SERVICE BULLETIN

Subject: GS Pinsetter Crank Arm Alignment

Bulletin No. SB12-8

Figure 1

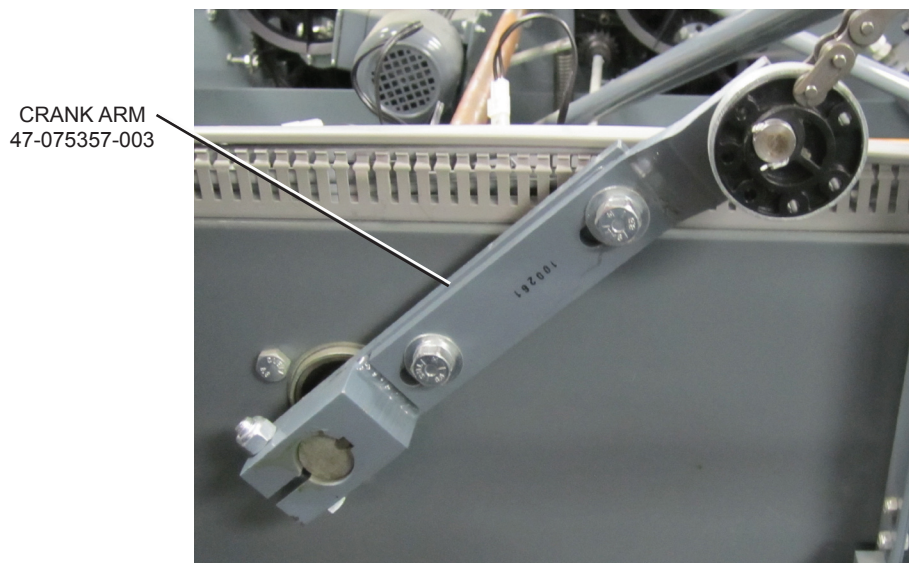
In April of 2008 there was a change in the thickness of the crank arm from 10mm to 12 mm. This occurred on machines with series numbers 644 and higher. Refer to Figure 1.

Figure 2

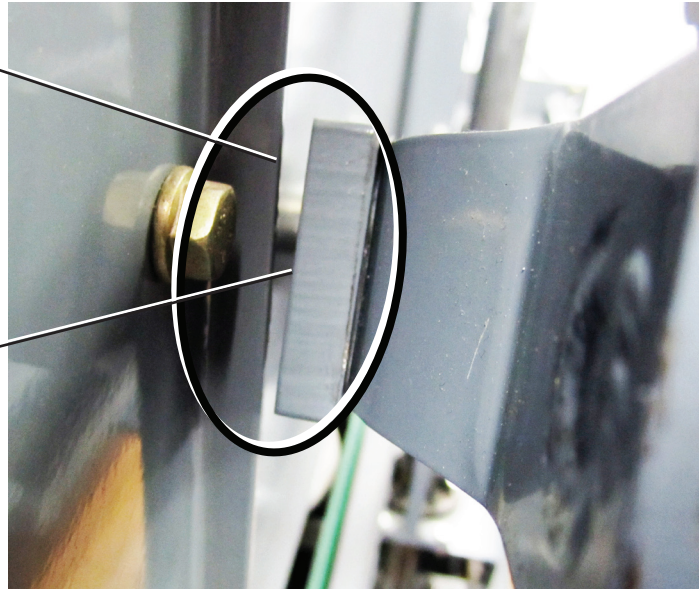
One of the things we have noticed is that if you have a machine that has the crank arm adjusted too far away from the distributor frame – in particular, the edge of the Sweep Shaft Support Brace (Refer to Figure 2), it can create a misalignment of the pivot bearing and the top spur gear when the crank arm is at the top of the stroke and closest to the spur gear – the pivot bearing is offset to the right of the spur gear (Refer to Figure 3).

CRANK ARM ADJUSTED TOO FAR AWAY FROM EDGE OF THE SWEEP SHAFT SUPPORT BRACE

Figure 8

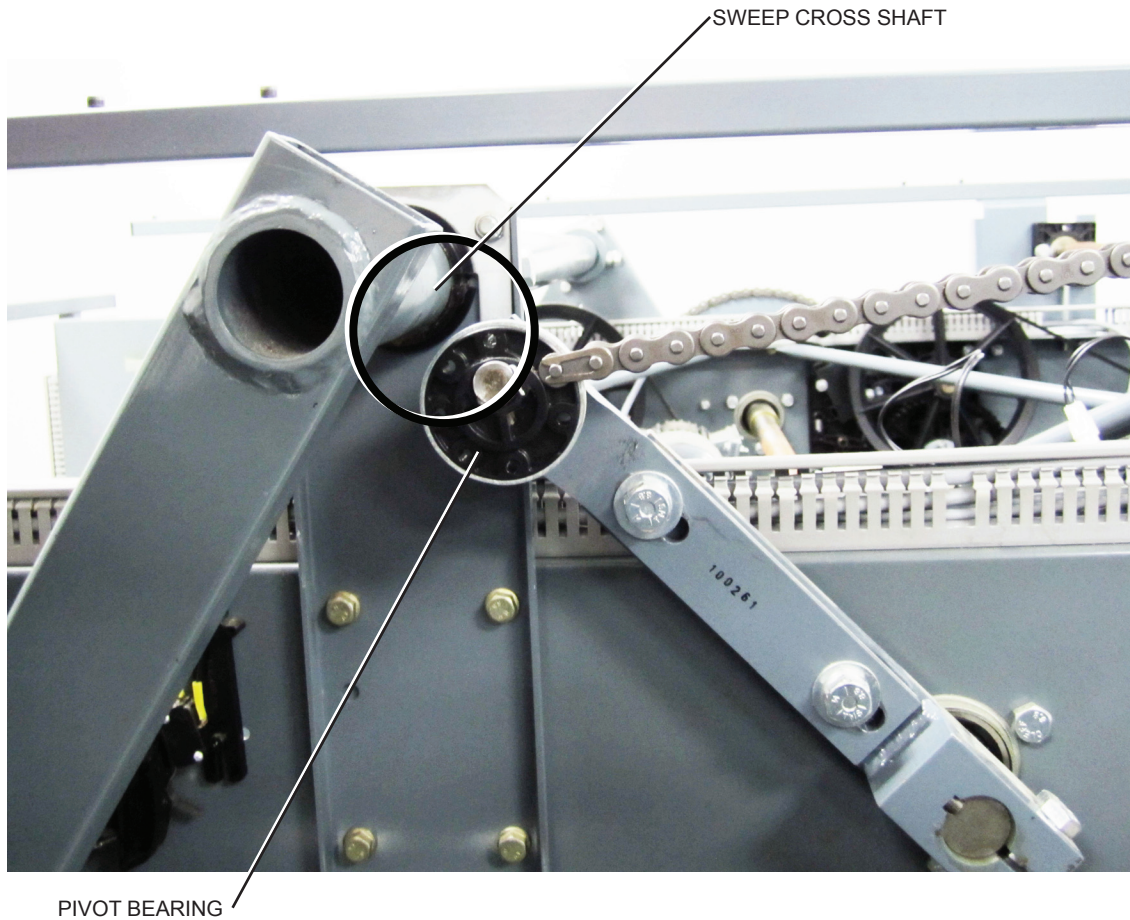
This is also a good time to ensure that the pivot bearing is not hitting the sweep cross shaft during the cycle. Refer to Figure 8. If the pivot bearing is contacting the sweep shaft, refer to the “Table Height Adjustment” in the GS Series Pinsetter Operations and Service Manual (p/n 47-902735-000 or 47-902748-000).
